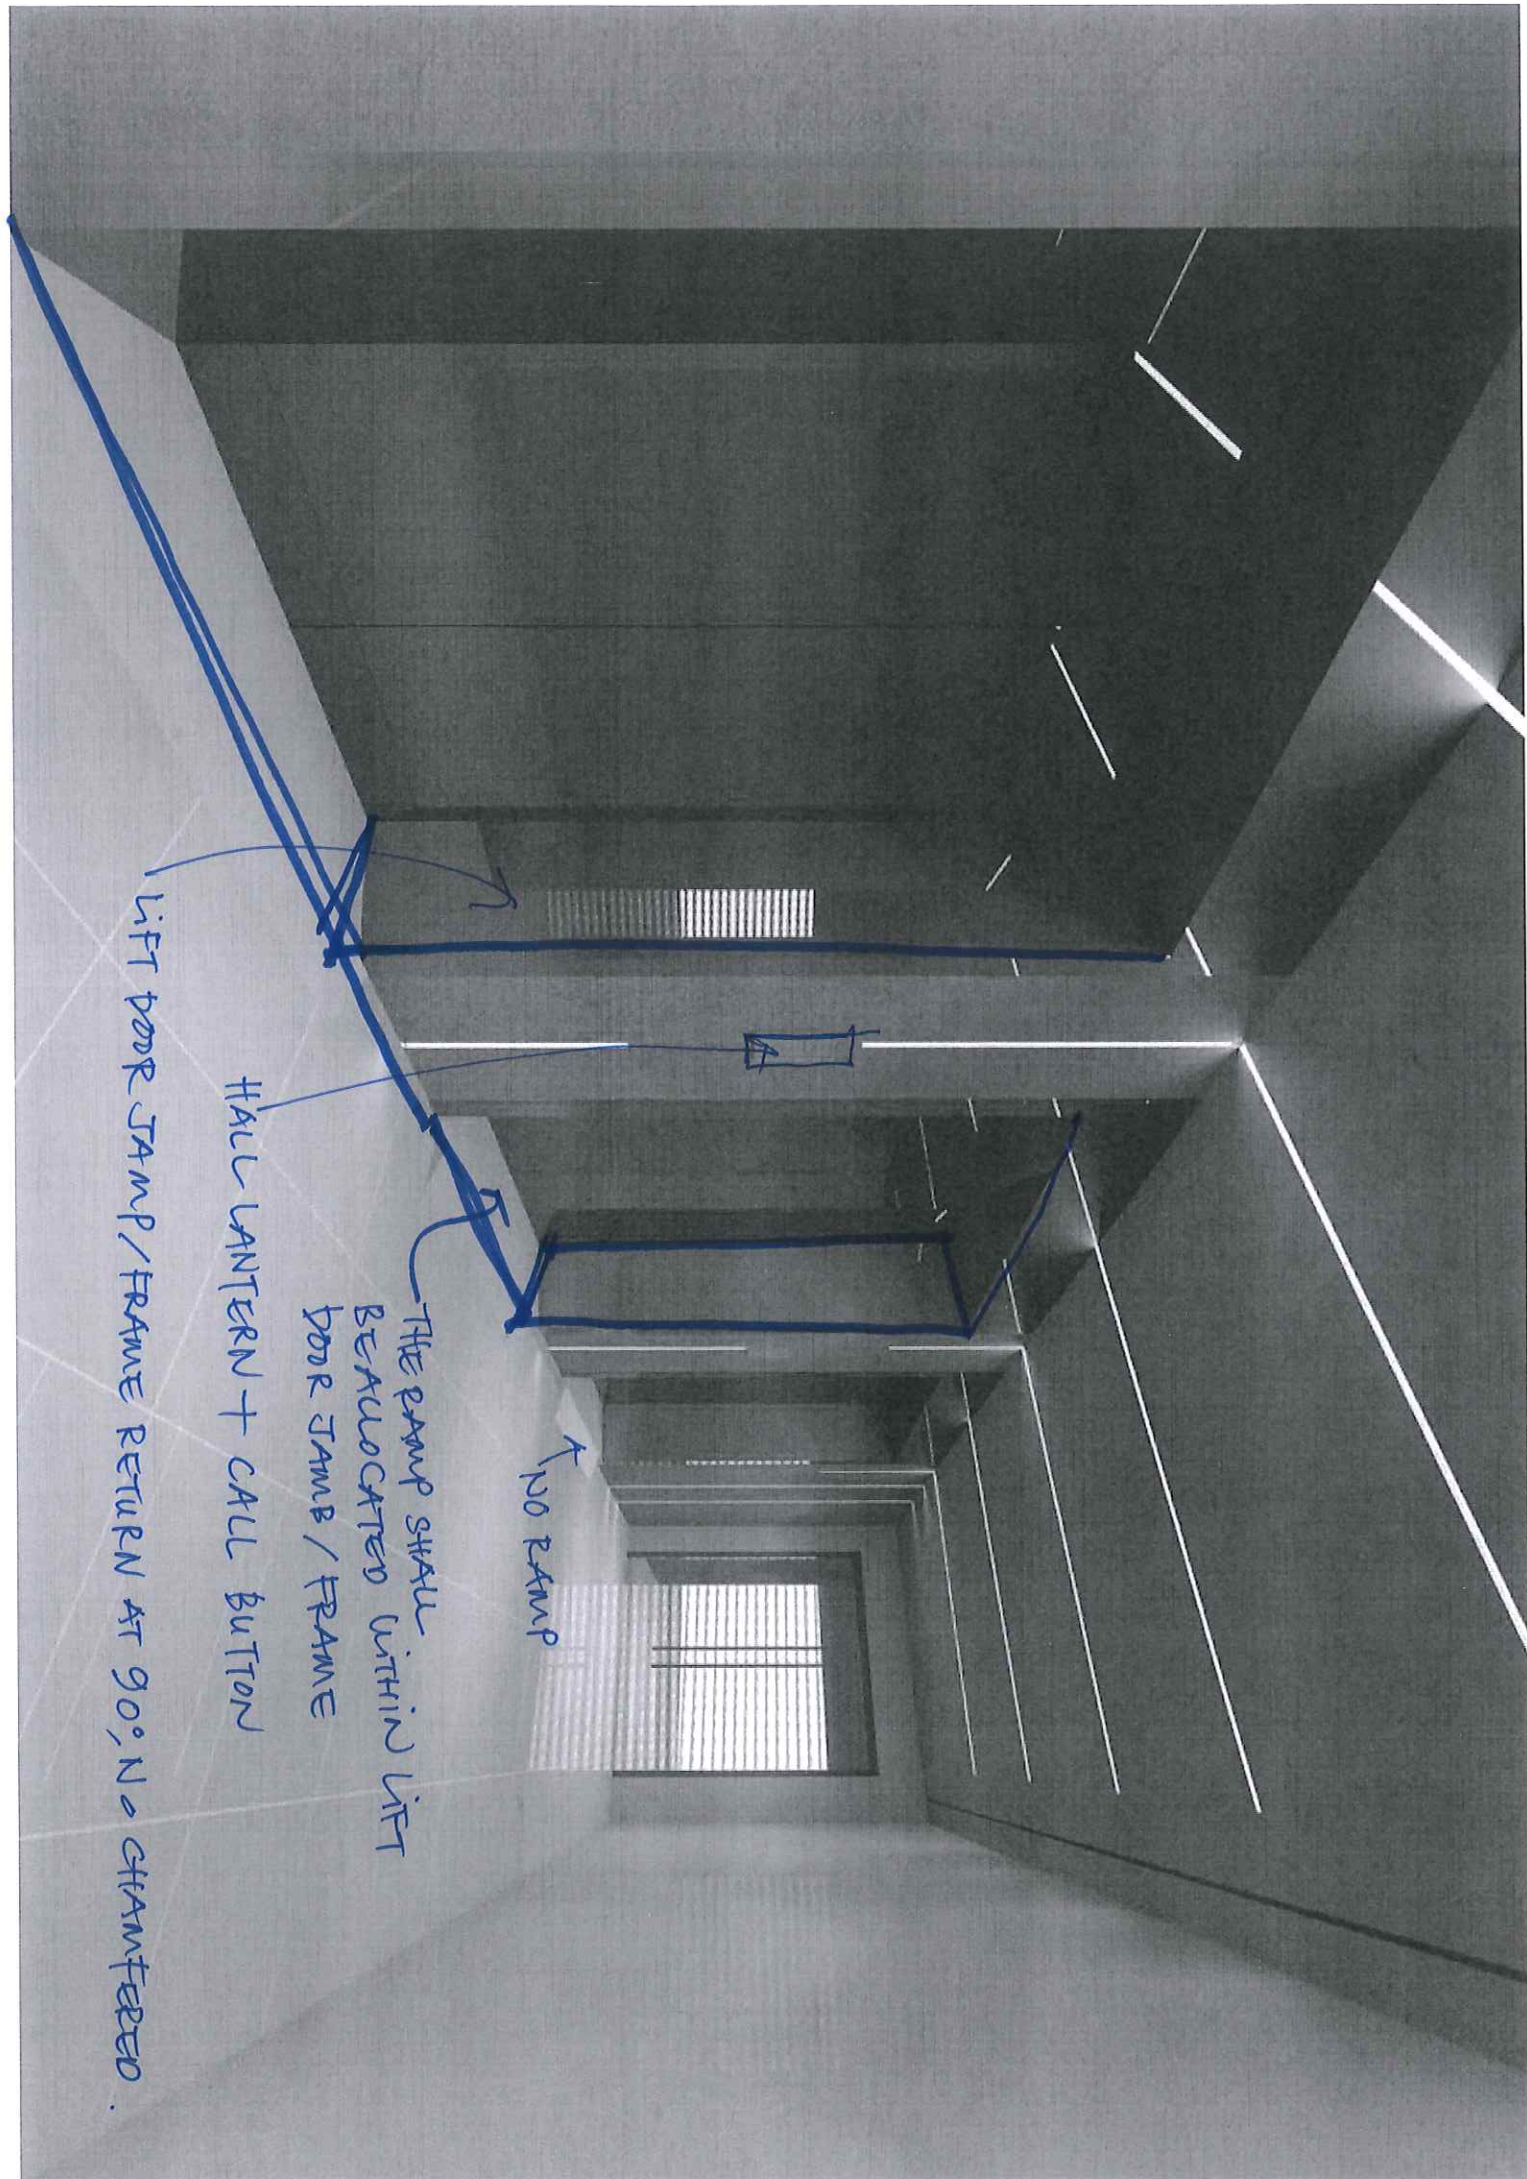
LIFT DOOR JAMP / FRAME RETURN AT 90°, NO CHANGING.

HALL LANTERN + CALL BUTTON

THE RAMP SHALL BE ALLOCATED WITHIN LIFT DOOR JAMB / FRAME

NO RAMP

special
landscape

Flooring
Material
→
Small & Follows
Landscape Architect's
Spec.

down the acrylic
panel in light blue

glass railing

glass railing.

over floor
gratings
